Department of Environmental Quality  
Division of Radiation Control

January 21, 2003

**SUBJECT:** September 2002 Final Site Observational Work Plan for the Green River, Utah  
UMTRA Site: DRC Comments

**July 2002 Potentiometric Surface of Cedar Mountain Middle Sandstone Unit  
including water level in well 180  
Green River UMTRA Site**

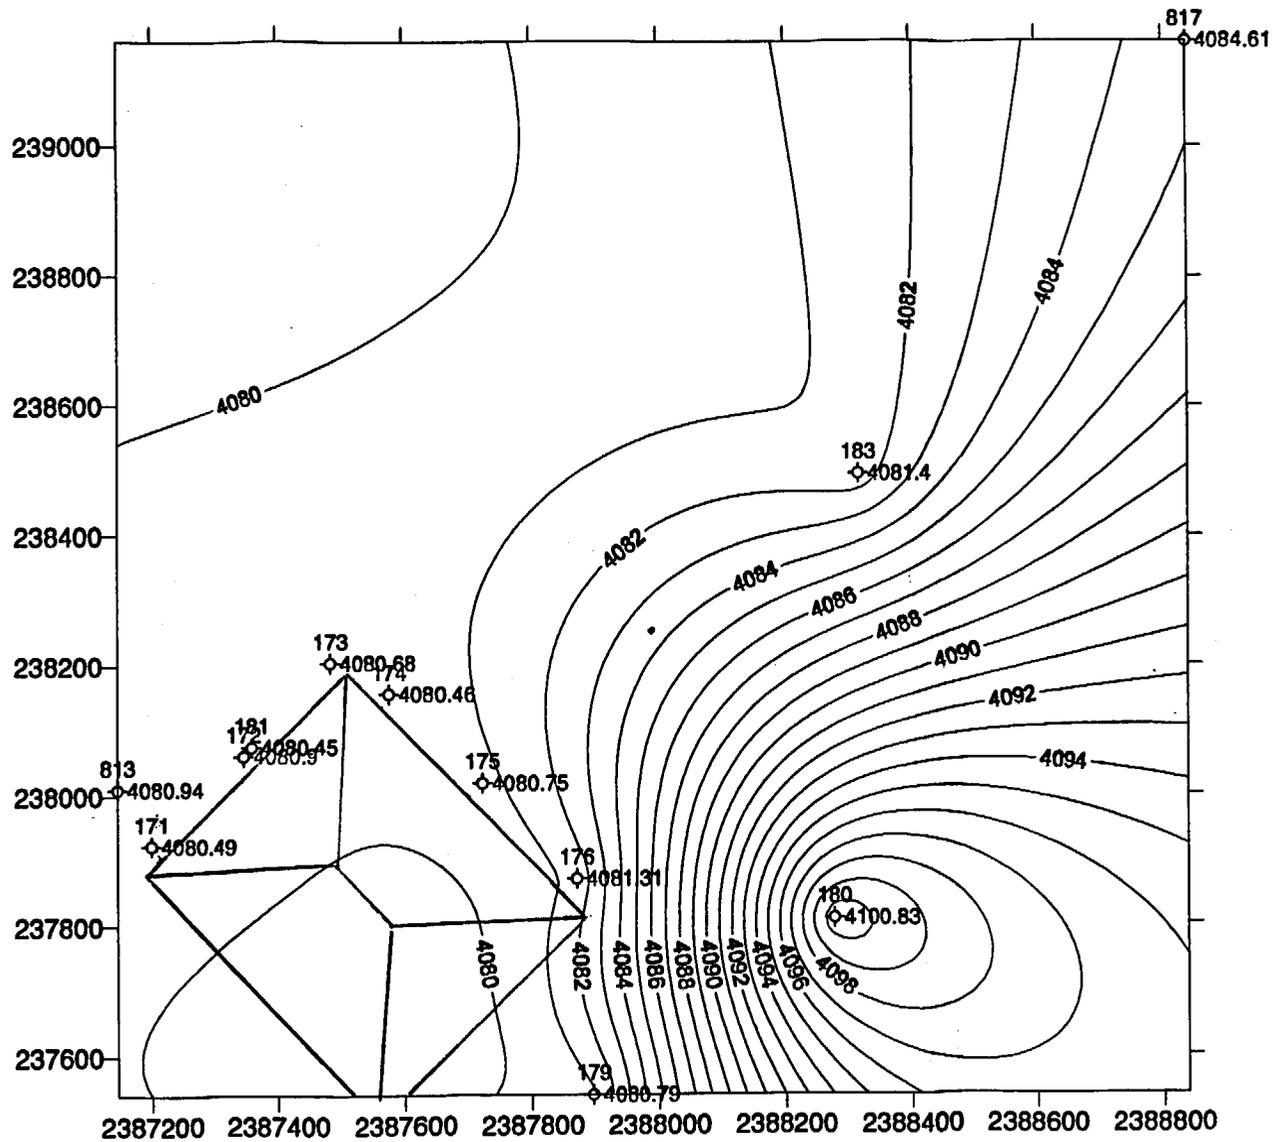
**Northwest Hydraulic Gradient.** After constructing a series of cross sections and correlating the sandstone units beneath the site, DRC staff constructed a map of the potentiometric surface for the middle sandstone unit of the Cedar Mountain Formation (Attachment 1). The data used for this map are summarized in Table 1 below with other hydrogeologic data.

The hydraulic gradient in Attachment 1 is consistent with the hydraulic gradient provided by the DRC in 1996 (Attachment 2). Both DRC maps include well 0180 as a data point and show an overall northwestward flow direction with a relatively flat hydraulic gradient in the vicinity of the disposal cell and a steep gradient east of the disposal cell. It is interesting to note that the hydraulic head in well 0180 has changed very little in seven years from a value of 4100.95 feet amsl in June 1995 to a value of 4100.83 in July 2002. Geologic cross sections and boring log correlations indicate that the well screens in monitoring wells 0177 and 0178 are completed in a different sandstone aquifer, referred to by DOE as lenticular stringer sandstones of the lower unit of the Cedar Mountain Formation. Based on lithologic descriptions, stratigraphic position, and geochemical signatures, the DRC concurs that the lower Cedar Mountain stringer sandstone aquifer is hydraulically connected with the Cedar Mountain basal sandstone unit, but hydraulically separated from the Cedar Mountain

The northwest hydraulic gradient depicted in Attachment 1 is supported by fracture and joint patterns at the Green River site and the structural dip of the middle sandstone unit. Figure 5-6 of the Final SOWP indicates a predominant northwest orientation of fractures and joints at the Green River site, which supports a northwest groundwater flow direction. In addition, a structure contour map constructed on top of the middle sandstone unit indicates a northern structural gradient with a slight northwest dip component in the vicinity of the disposal cell (Attachment 4). The combination of a northern structural gradient with a northwest fracture orientation is consistent with the northwest hydraulic gradient in Attachment 1.

If the hydraulic gradient is to the northwest as indicated by DRC Attachment 1, proposed POC wells 0171, 0173, 0181, and 0813 are adequate locations for monitoring ACLs for the Cedar Mountain middle sandstone unit. Although proposed POE well 0182 is in an appropriate location for a northwest hydraulic gradient, this well is screened across the basal sandstone unit of the Cedar Mountain Formation, not the middle sandstone unit. Because the basal sandstone unit of the Cedar Mountain Formation has a strong upward hydraulic gradient and is hydrogeologically isolated from the middle sandstone unit, it has not been contaminated by site-related activities. As a result, well 0182 cannot serve as a POE well for the Cedar Mountain middle sandstone unit. Therefore, a POE well needs to be installed near the downgradient edge of the State property boundary with a screened interval across the middle sandstone unit of the Cedar Mountain Formation.

July 2002 Potentiometric Surface of Cedar Mountain Middle Sandstone Unit  
excluding water level in well 180  
Green River UMTRA Site

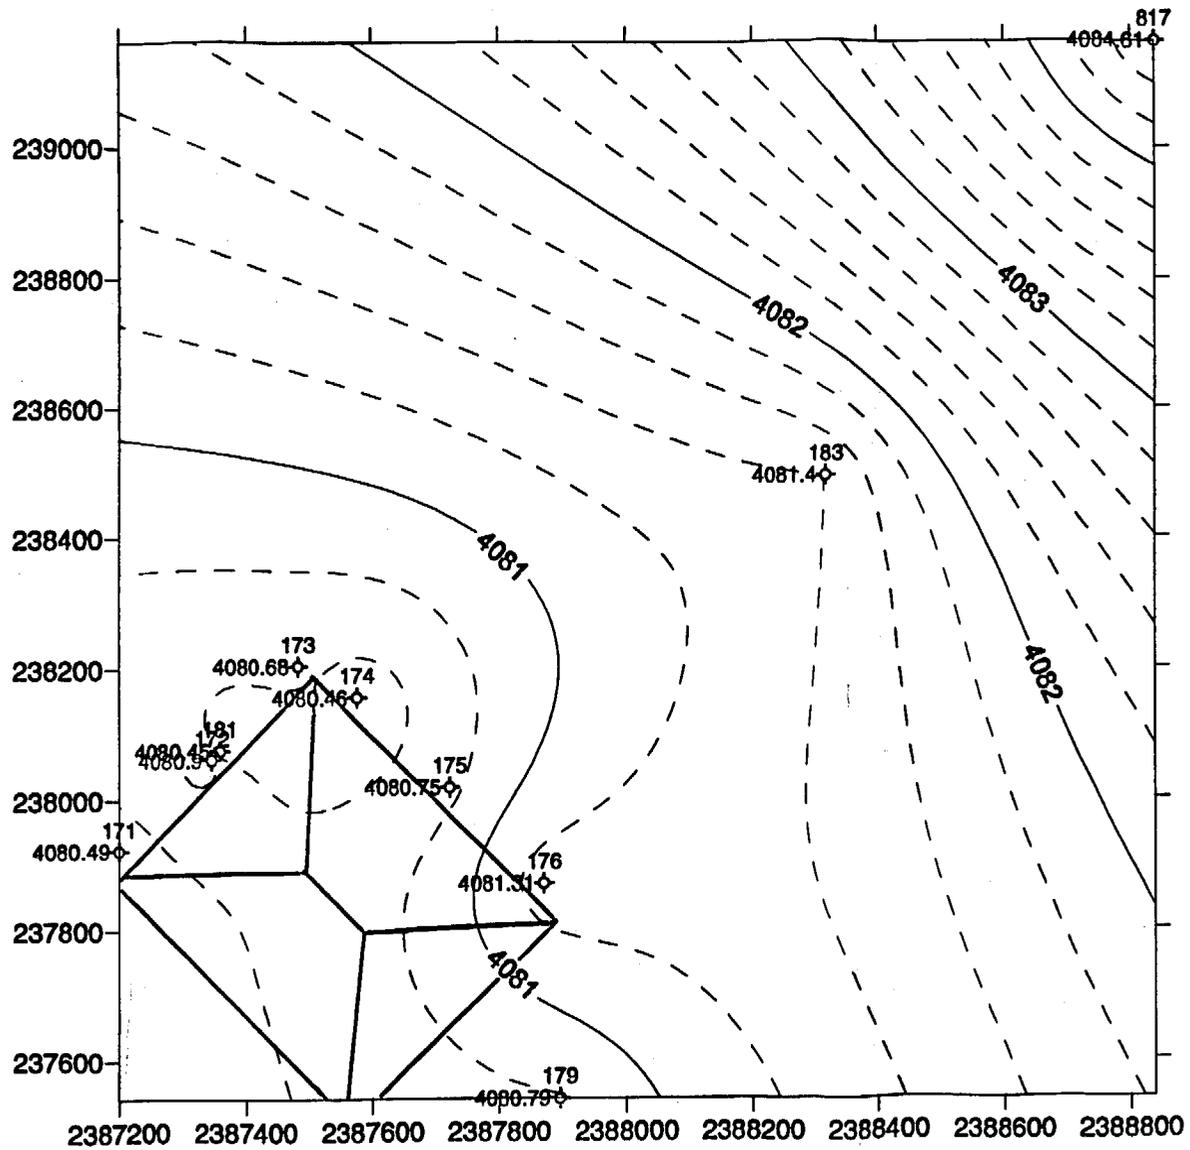
Southwest Hydraulic Gradient. Figure 5-9 of the Final SOWP depicts a southwest hydraulic gradient towards the Green River regional discharge area. The difference between the potentiometric surface depicted in DRC Attachment 1 and Figure 5-9 of the Final SOWP is caused by the presence or absence of the head measurement in well 0180. The DRC map in Attachment 1 includes the head elevation in well 0180 while Figure 5-9 of the Final SOWP does not. By removing the head measurement of well 0180 from the data set, DRC staff replicated the potentiometric surface in Figure 5-9 of the Final SOWP (Attachment 3). However, correlations of boring logs in DRC cross sections show that the middle sandstone unit of the Cedar Mountain Formation is present in well 0180 from 4079.20 and 4067.20 feet elevation above mean sea level (amsl). This sandstone correlates with the sandstone present from 4113.70 to 4073.70 feet amsl in well 0179 to the southwest, and the sandstone present from 4030.00 and 4011.00 feet amsl in well 0183 to the northeast. Because wells 0179, 0180, and 0183 are all completed in the middle sandstone unit of the Cedar Mountain Formation, the water level elevation measured in well 0180 should be included in the potentiometric surface map for the middle sandstone unit of the Cedar Mountain Formation.
